## **Notice of Wasatch County Planning Commission Meeting** **Thursday, May 14, 2026, at 6:00 PM**

**Project:** DEV-11816 | Lake Creek 40-acre subdivision  
**Meeting Date:** 14 May 2026  
**Report Date:** 7 May 2026  
**Report Author:** Doug Smith, Planning Director  
**Council Action Required:** No  
**Type of Action:** Administrative

**Project:** DEV-10755 Valor Estates Subdivision  
**Meeting Date:** 14 May 2026  
**Report Date:** 7 May 2026  
**Report Author:** Doug Smith, Planning Director  
**Council Action Required:** No  
**Applicant:** MCM Engineering

# Exhibit C – Site Plan

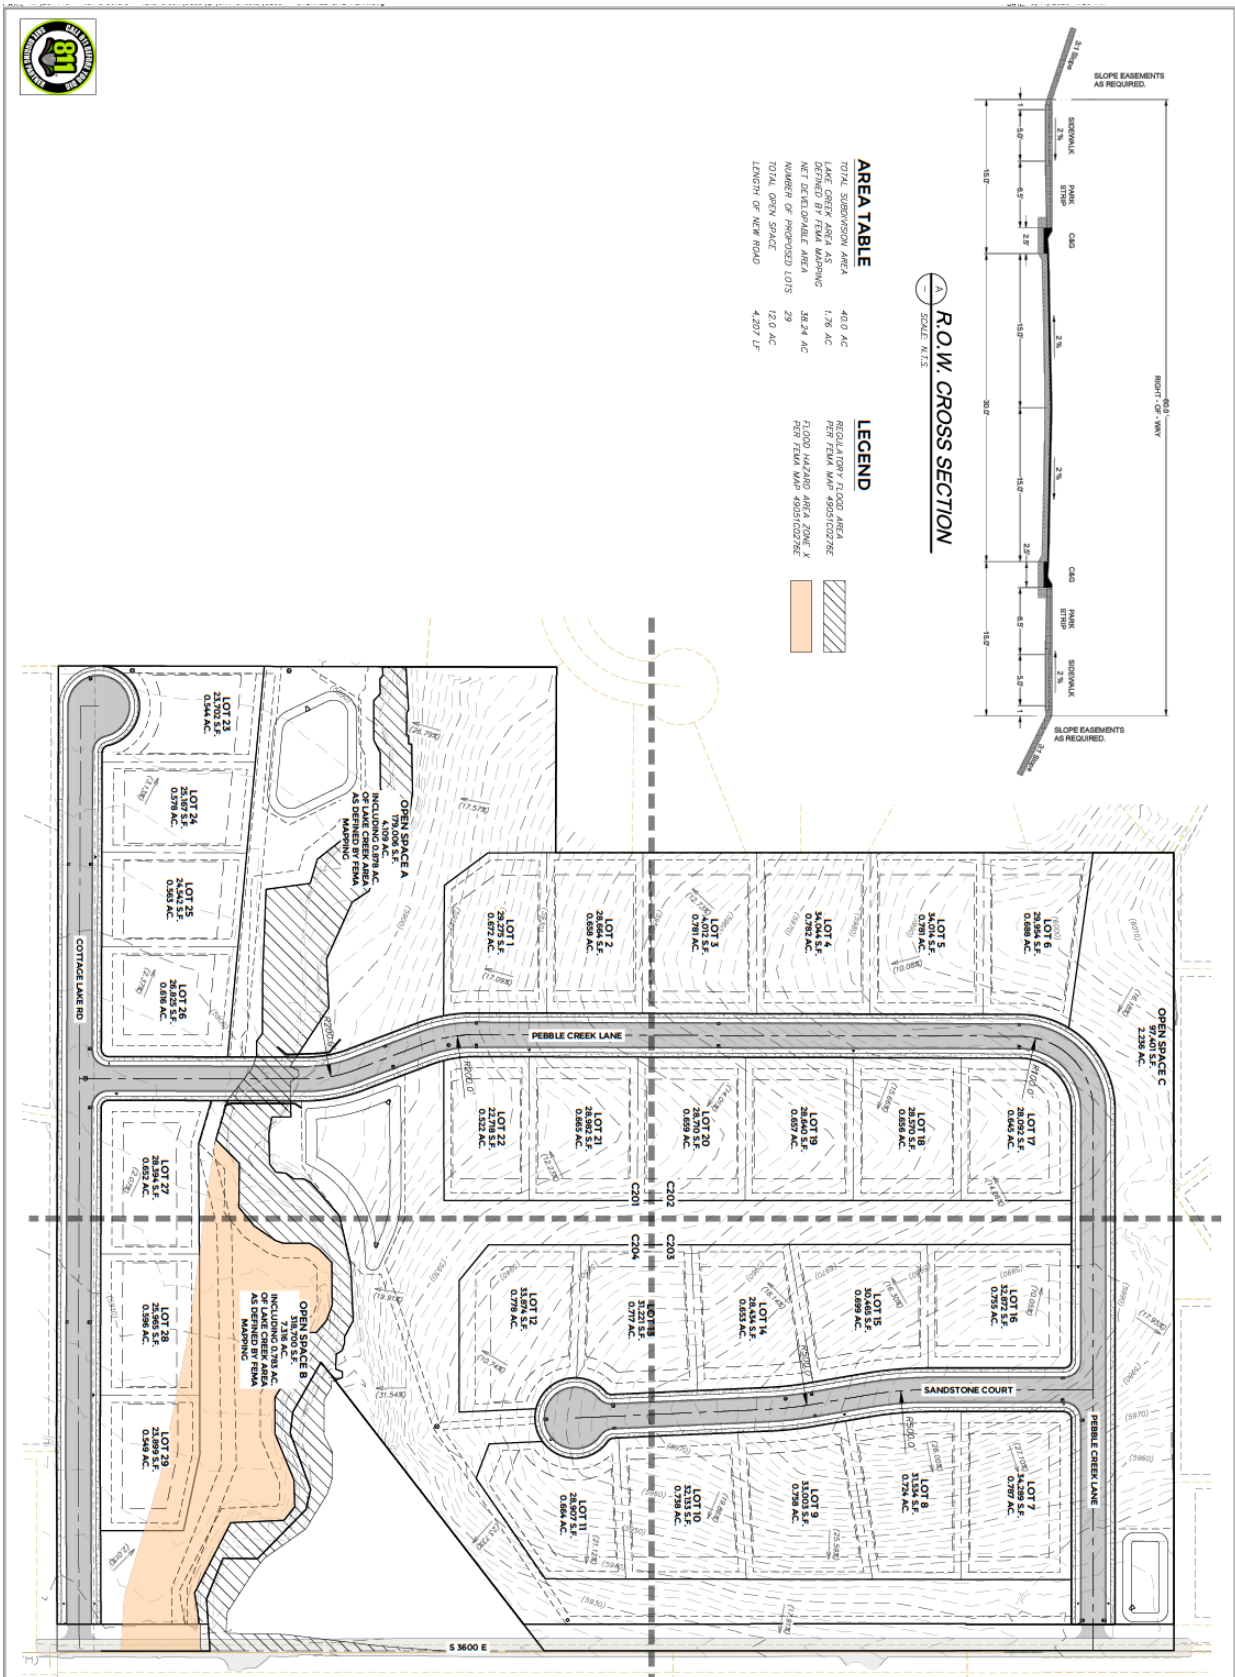
DRC - Engineering Dept		
Comment ID	Sheet Name	Comment
DRC-ENG9	03 - Site Plan	Note: The County will be improving 3600 East in 2026. It is recommended to coordinate with Public Works to avoid road cuts once the road is completed.
DRC-ENG22	09 - Drainage Plan	Note: A floodplain permit and associated no-rise analysis will be needed for the floodway crossing with final permit application.

proposed to be buried?
DRC-PLN7	15 - DevAgreement	You may be required to have a development agreement if there is a portion of the ROW that you have responsibilities to maintain. We may want to discuss this further with the County attorney. This is due to the 3600 E frontage easements.
DRC-PLN8	03 - Site Plan	The applicant will need to show that the trails will connect all the way through 3600 E and with any existing or future trails with the Crossings
DRC-PLN9	03 - Site Plan	Please verify that all streets comply with 26.27.29(B.) and (C.)

Exhibit D – Prior Layout

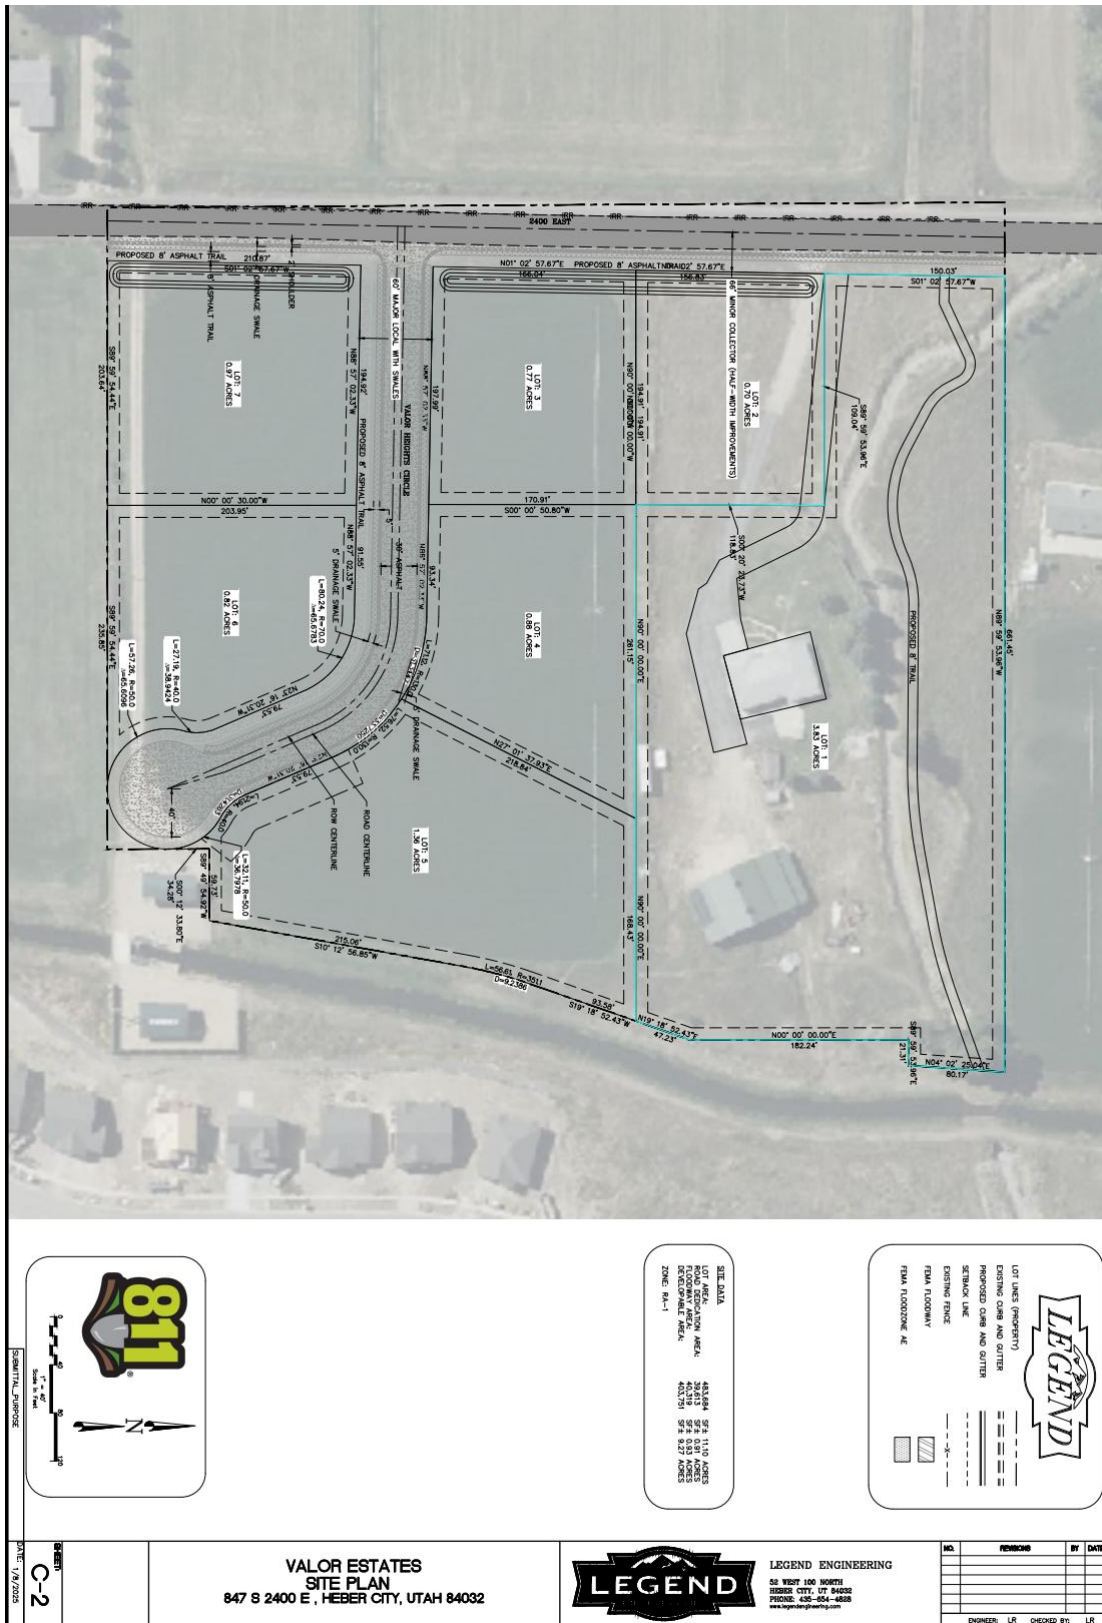
As mentioned above, the application was made in June of 2025. The first submittal did show a cul-de-sac stubbed to the south property line that could have been a future connection to the south. The subsequent four

reviews did not show the cul-de-sac stubbed to the property line. There was discussion about the stubbed cul-de-sac and CUP (Central Utah Project) infrastructure as part of a DRC meeting. In discussion with the CUP and the previous engineering company it was mentioned that the change might have been due to access/impacts to the CUP infrastructure as well as alignment of the cul-de-sac and future lot layout with the property to the south. The last three review cycles showing the current cul-de-sac configuration were signed off by the planning department and no mention of the through street requirement was made.

DRC – Planning Dept		
Comment ID	Sheet Name	Comment
DRC-PLN11	03 - Site Plan	After doing research to see if the lot was a legal nonconforming lot, I found partial information that a caretaker unit was approved on a 9.92 acre lot in 1982. looking thru the Planning Commission book, I could not find the commission minutes or address for this. Current ordinance (16.21.46 ) Require caretaker units to have a minimum of 10 acres for approval. if a second unit exists on the property, you could potentially subdivide the care taker unit from the house as an option.  Carry over from previous review. Please address this comment.
DRC-PLN13	02a - Plat	The signature box for weed board, solid waste, and recreation district are not required.  Please verify that all the information listed in section 16.27.12 Final Plat is on the subdivision Plat. It appears some required information is not on the plat.
